IN THE DRAWING

REMARKS

Fig. 2

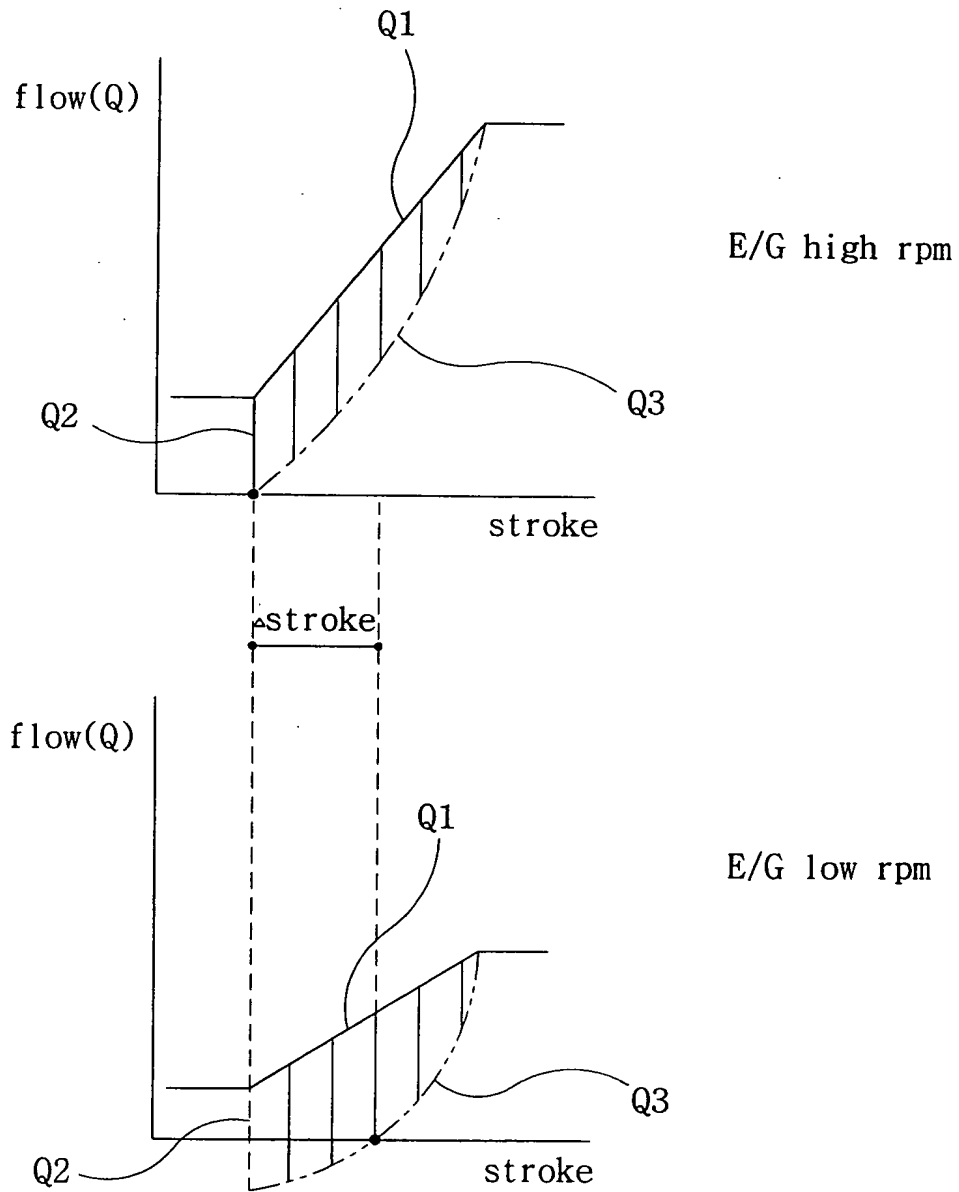
The Examiner has pointed out that some claims of the invention are not novel because of the cited reference, JP07-317706. However, the cited reference is installed in a center bypass path, and that means constant discharge amount of fluid from pump to tank is subtracted irrespective of the pressure of the supply path to cylinder. That can cause some problem in the low speed mode of engine, in which it cannot fully supply the discharge amount of fluid to the cylinder, as can be seen in Fig. 2 (prior art) of the invention.
